10/695,400

Office Action Summary

FITZGERALD ET AL.

DETAILED ACTION

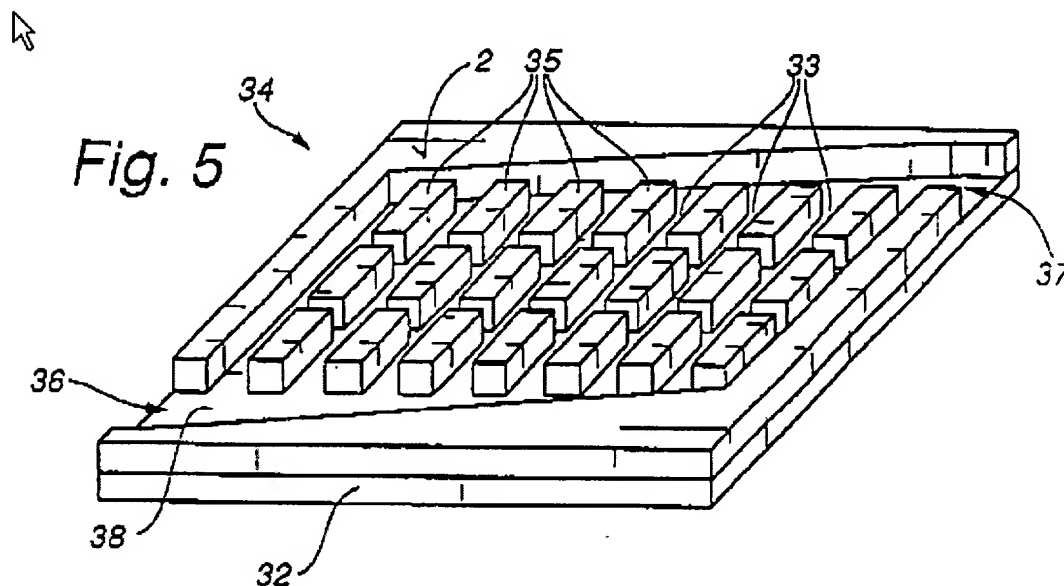
Fuesser teaches a microcooling device. The method comprises flowing a first fluid stream into a manifold and then through a first channel in a first direction and flowing a portion of the first fluid stream to a second channel. The second channel extends at a nonzero angle relative to the first direction. (See Figure 5) The second channel comprises a microchannel and comprises at least one dividing wall that separates the second channel into at least a first and a second subchannel. The first layer and the manifold are each substantially planar. (See Figure 5) The manifold is substantially contained within the first layer. The first layer and the manifold are substantially coplanar. (See Figure 5) The first channel is disposed in the first layer and flow through the first channel is substantially parallel to the plane of the first layer. The first channel and the manifold are about the same height. (See Figure 5) The

second layer is substantially planar and the second channel is disposed in the second layer and flow through the second channel is substantially parallel to the plane of the second layer. The first layer and the second layer are substantially parallel and the nonzero angle refers to an angle within the second layer. (See Figure 5)

Fuesser further teaches a plate comprising an opening is disposed between the first and second layers and flow from the first layer passes through the opening into the second layer. (See Figure 5) Additionally, Fuesser teaches the first layer comprises multiple adjacent parallel microchannels separated by channel walls and the second layer comprises multiple adjacent parallel microchannels separated by continuous channel walls. The continuous channel walls traverse the width of the multiple adjacent parallel microchannels in the first layer. (See Figure 5) The second layer is made from a sheet containing slots. It is inherent that the second layer tends to equalize flow through the multiple adjacent parallel microchannels in the first layer.
